Product Change Notification

Document No. **PCN-A-20240516** Revision **1.0**

M116 Series LAN Port Design Change

<i>Original</i>	<i>New</i>
Appearance

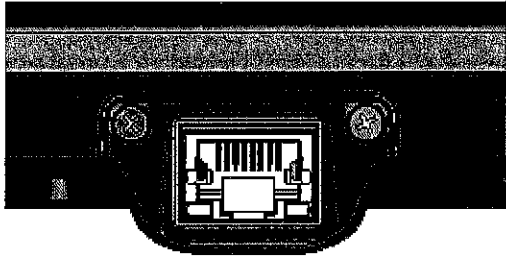
M116 series tablet LAN port design change to decrease the height of the LAN port connector.

Critical Change: outside dimension changes

Due to the outward improvement, Winmate will change the LAN component to decrease the height of the LAN port connector to make the outward smoother. And the design change is not related to any function that M116 series tablets already have.
